From: WELLS Russell D (AREVA NP INC) [Russell.Wells@areva.com]
Sent: Friday, February 27, 2009 7:41 PM
To: Getachew Tesfaye
Cc: BENNETT Kathy A (OFR) (AREVA NP INC); Pederson Ronda M (AREVA NP INC); DELANO Karen V (AREVA NP INC)
Subject: Response to U.S. EPR Design Certification Application RAI No. 135, Supplement 1
Attachments: RAI 135 Supplement 1 Response US EPR DC.pdf

Subject: Response to U.S. EPR Design Certification Application RAI No. 135,
Supplement 1
Sent Date: 2/27/2009 7:41:22 PM
Received Date: 2/27/2009 7:41:50 PM
From: WELLS Russell D (AREVA NP INC)

**QUESTIONS for Containment and Ventilation Branch 1 (AP1000/EPR Projects)
(SPCV)**

Figure 2.6.1-1—Control Room Air Intake and Iodine Filtration Train Subsystem Functional Arrangement

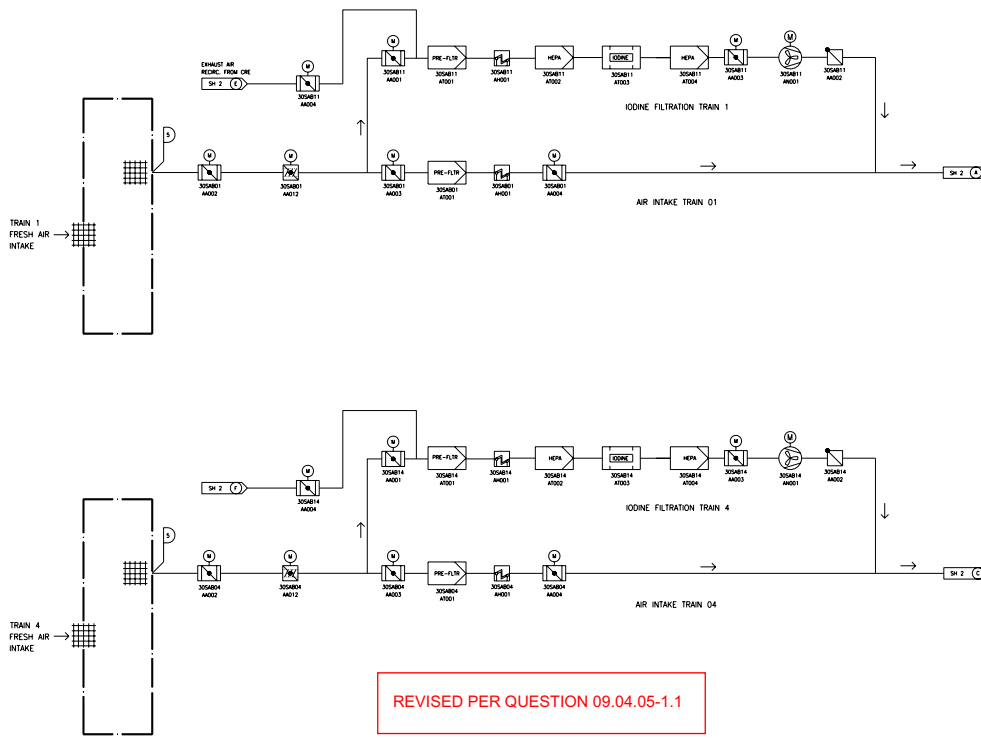
Tier 1 FSAR Table 2.6.1-2 and Tier 2 Tables 3.2.2-1 and 3.11-1 lists two motorized dampers in the Division 2 – Air Intake Train 2 and Division 3 – Air Intake Train 3, but FSAR Tier 1, Figure 2.6.1-1 shows only one motorized damper in trains 2 and 3 as does FSAR Tier 2, Figure 9.4.1-2.

Due to the identified single failure concern, the design was changed to add a second CREF unfiltered bypass duct motor operated isolation damper (30SAB01AA003 or 30SAB04AA003) for each of the CREF iodine filter units.

Tier 2 FSAR Figure 9.4.1-1 and Tier 1 FSAR Figure 2.6.1-1 will be revised (see response to Question 09.04.05-1.1) to show a second motor operated isolation damper in the CREF unfiltered bypass ducting.

Figure 2.6.1-2—Control Room Air Conditioning and Recirculation Air Subsystem Functional Arrangement

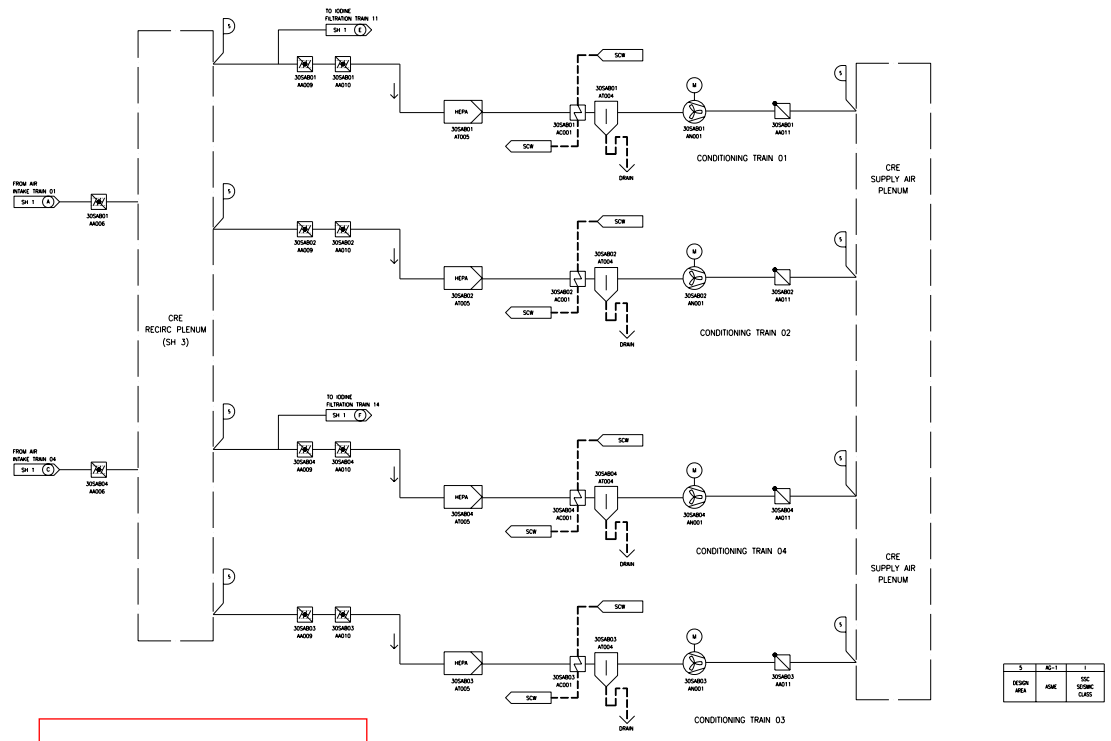
The applicant states in Tier 2 FSAR Section 16, Technical specification B 3.7.11, with one division out of service for maintenance and second lost to single failure, the two operable CRACS trains maintain the MCR temperature. However, if both trains in a division are lost, the P&ID (Tier 2 FSAR Figure 9.4.1-3) shows no supply air flow to half the CRE areas.

U.S. EPR FSAR Tier 2, Figures 9.4.1-1, 9.4.1-2, and 9.4.1-3 and U.S. EPR FSAR Tier 1, Figures 2.6.1-1, 2.6.1-2, and 2.6.1-3 will be revised to clarify the common supply and recirculation air plenum interconnection to the control room air conditioning system (CRACS) (refer to the response to Question 09.04.05-1.1).

U.S. EPR FSAR Tier 1, Figures 2.6.1-2 and 2.6.1-3 and U.S. EPR FSAR Tier 2, Figures 9.4.1-2 and 9.4.1-3 will be revised to show the common supply plenum, the common recirculation plenum, and to show a single supply duct (refer to the response to Question 09.04.05-1.1).

Figure 2.6.4-1—Fuel Building Ventilation System Functional Arrangement

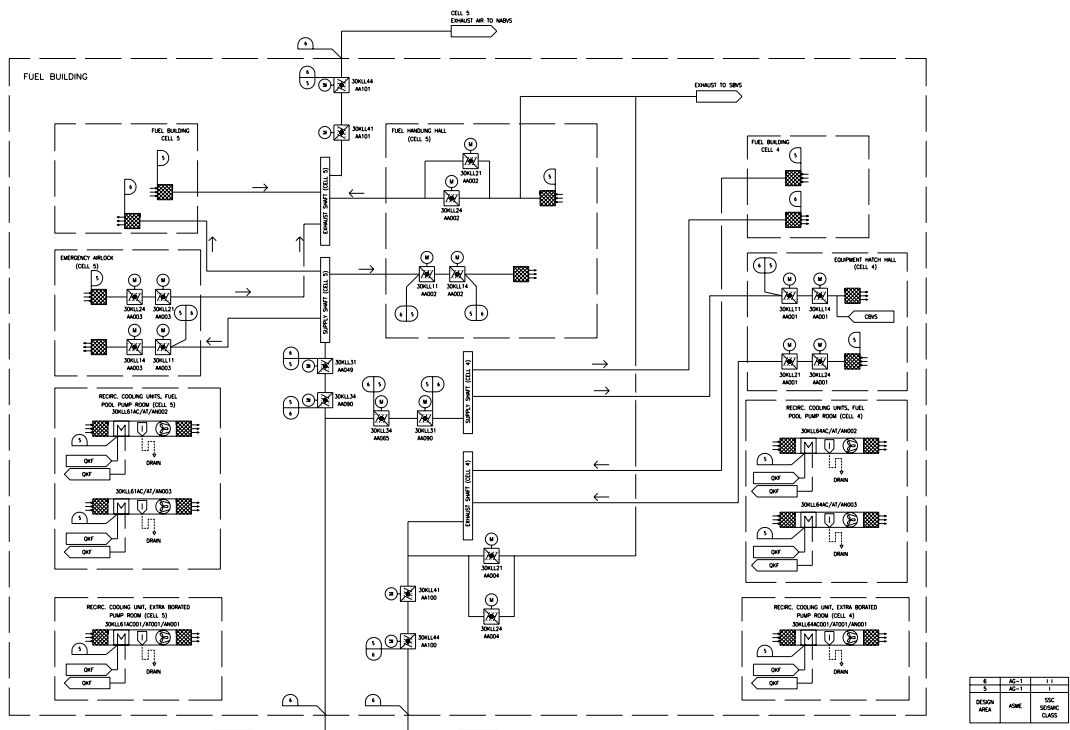
2. There are drawing discrepancies between Tier 1 FSAR Figure 2.6.4.1 and Tier 2 FSAR Figure 9.4.2-1.
 - a. In Tier 1 FSAR Figure 2.6.4-1, the Recirculation Cooling Units, Extra Borated Pump Room Cell 4 (lower right of drawing), and Cell 5 (lower left of drawing) indicate SCW as the cooling water interface. For the same equipment depicted in Tier 2 FSAR Figure 9.4.2-1, it indicates QKF as cooling water interface.

- b. Tier 1 FSAR Figure 2.6.4-1, the Recirculation Cooling Units, Fuel Pool Pump Room Cell 4 (lower right of drawing) indicates CCW as the cooling water interface. For the same equipment depicted in Tier 2 FSAR Figure 9.4.2-1, it indicates KAB as cooling water interface.

- c. For the exhaust ductwork connected to SBVS (vertical run on drawings) Tier 1 FSAR Figure 2.6.4-1 indicates ductwork between valve group 30KLL21/24AA004 as seismic class N/A, but Tier 2 FSAR Figure 9.4.2-1 indicates this same ductwork as seismic class I.

2. The design area, quality group, and seismic class in U.S. EPR FSAR Tier 1, Figure 2.6.4-1 and U.S. EPR FSAR Tier 2, Figure 9.4.2-1 will be revised. In addition the water supply to the recirculation cooling units in the fuel pool pump rooms will be changed from component cooling water (CCW or KAB) to the safety chilled water (SCW or QKF). The moisture separator symbols are also shown for the recirculation cooling units in the fuel pool pump rooms.

These changes resolve the drawing discrepancies between U.S. EPR FSAR Tier 1, Figure 2.6.4-1 and U.S. EPR FSAR Tier 2, Figure 9.4.2-1.

Figure 2.6.6-2—Safeguard Building Controlled-Area Ventilation System Exhaust Air Functional Arrangement

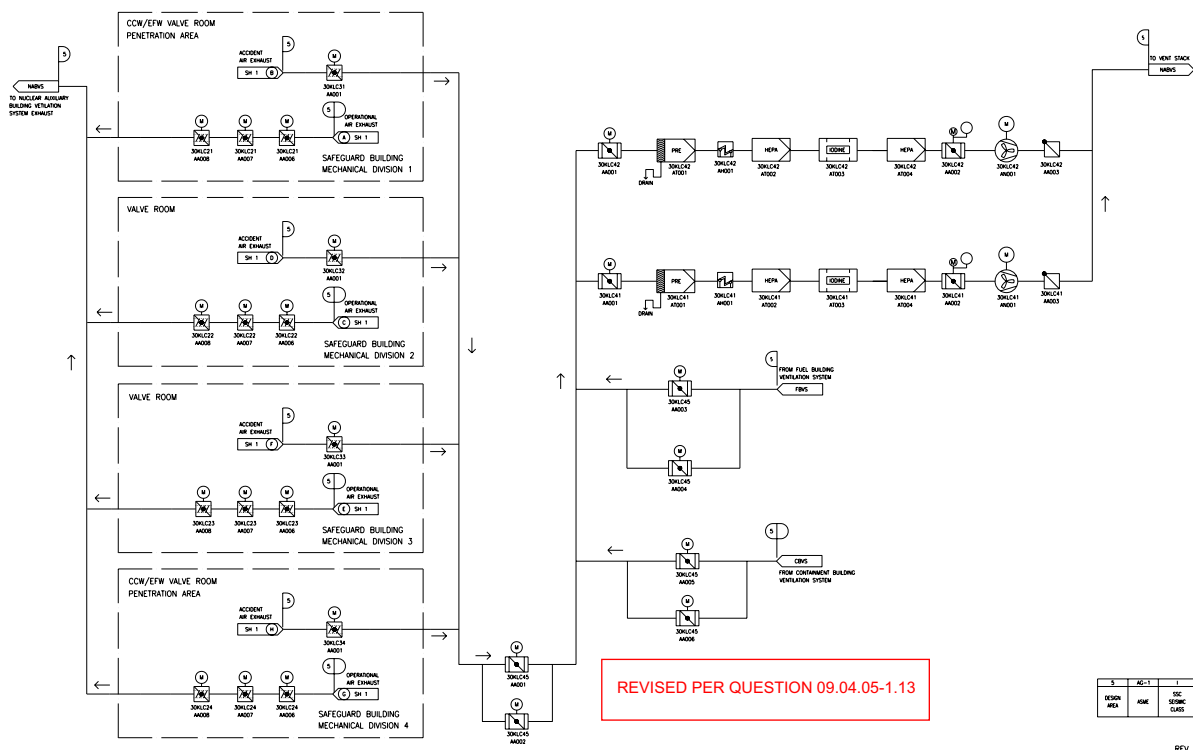
- a. Justify the omission of a moisture separator in the SBVS accident exhaust iodine filtration trains.
- b. Justify installing a heater upstream of the SBVS pre-filter with the intent to remove entrained moisture.

The design has been revised to replace the safeguard building ventilation system (SBVS) iodine filtration unit prefilter with a moisture separator and to relocate the preheater downstream of the moisture separator.

The drawings of the safeguard building exhaust air system in both Tier 1 and Tier 2 will be revised to reflect this design change. The symbol legends in Tier 1 and Tier 2 of the U.S. EPR FSAR also will be revised to add a symbol for the moisture separator prefilter. In addition, the

Figure 9.4.1-1—Control Room Air Intake and Iodine Filtration Train Subsystems

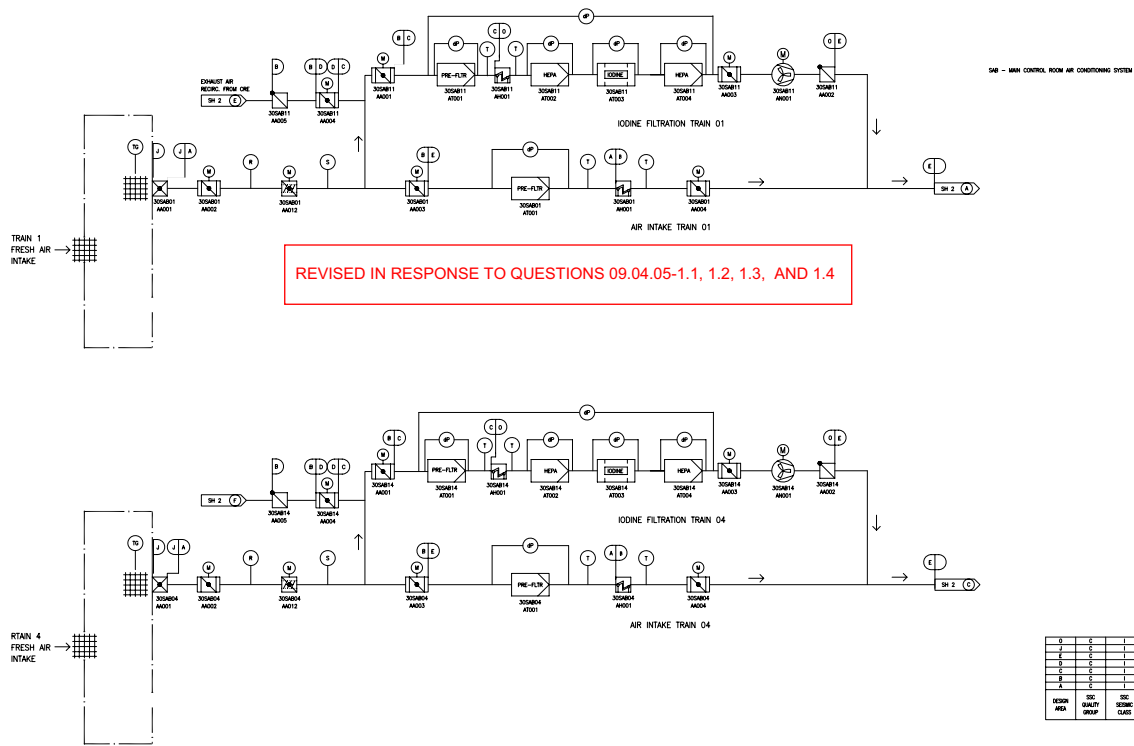
A review of the main control room air conditioning system (CRACS) P&IDs in FSAR Tier 2 Figures 9.4.1-1 and 9.4.1-2 shows that figure numbers and titles are incorrect.

Tier 2 FSAR Figures 9.4.1-1, 9.4.1-2, and 9.4.1-3 show that many of the fire dampers and their associated ductwork are classified as Seismic Category II and electric heaters classified as non-seismic. This is contrary to the statement in Tier 2 FSAR Section 9.4.1.1 that all components of the CRACS are safety-related and designed to Seismic Category I. Additionally, Tier 2 FSAR Table 3.2.2-1 and 3.11-1 list some components NSC, NS-AQ and Seismic Category II.

- a. Identify the locations of smoke detectors on the P&IDs (Tier 2 FSAR Figures 9.4.1-1 through 9.4.1-3).
- b. Clarify the reaction of the system to each of the following: external fire, external toxic gas release, smoke, or excessive concentration of CO and CO₂.

U.S. EPR FSAR Tier 2, Figures 9.4.1-1, and 9.4.1-2 will be revised to add smoke detectors (See the response to Question 09.04.05-1.1).

Figure 9.4.3-3—Nuclear Auxiliary Building Exhaust Filtration Trains Subsystem

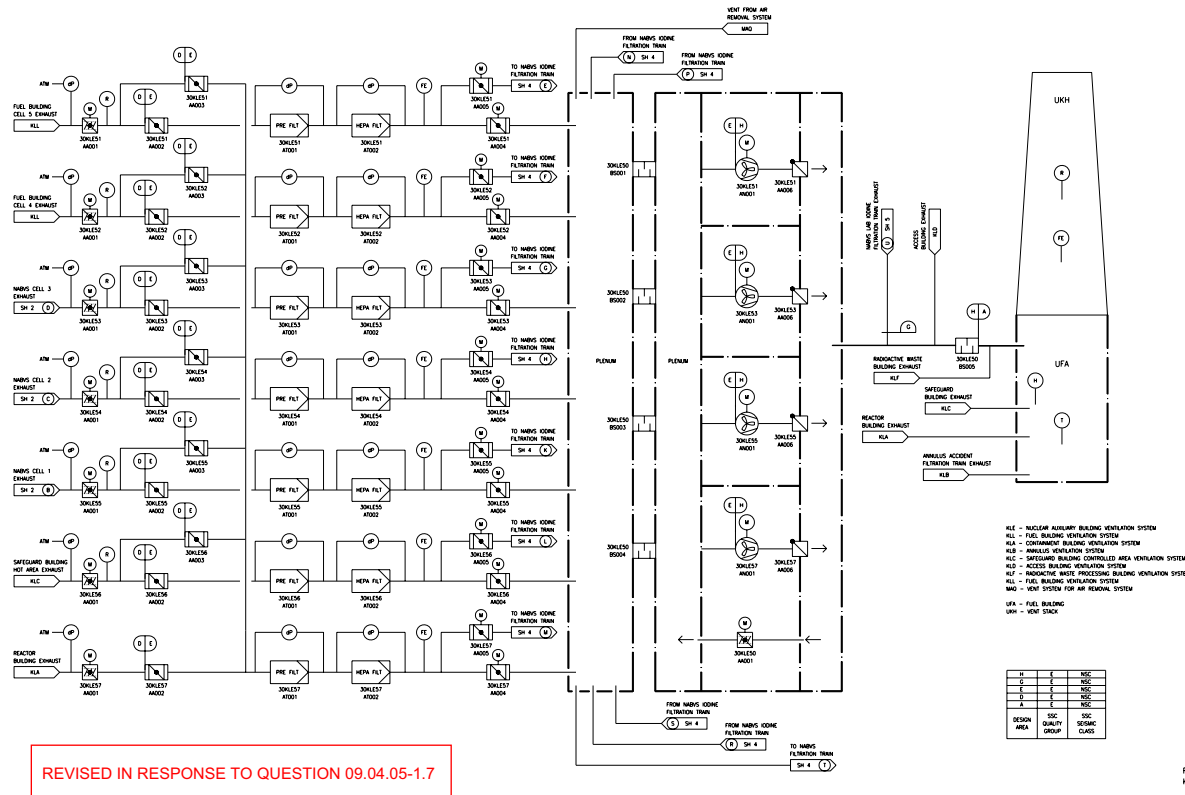
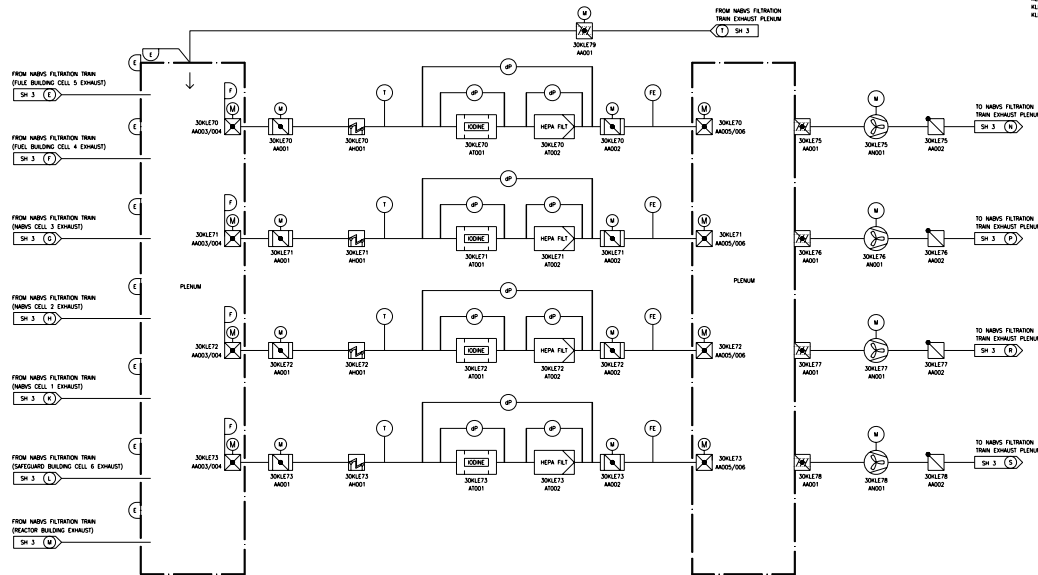
Regulatory Guide 1.140 recommends the monitoring of pertinent pressure drops and flow rates. The P&ID's do show differential pressure measurements across filters for the NABVS and RWBVS. There is very little instrumentation shown with regards to measuring flow rates. Also, there appears to be no system pressure monitoring for the NABVS. Confirm that the pressure and flow indication currently shown on the P&ID's for the NABVS and RWBVS is correct. If this indication is correct, justify that you meet RG 1.140, Position C3.3.

U.S. EPR FSAR Tier 2, Figures 9.4.3-3 and 9.4.3-4 (NABVS) and Figure 9.4.8-2 (RWBVS) will be revised to add flow rate element sensors.
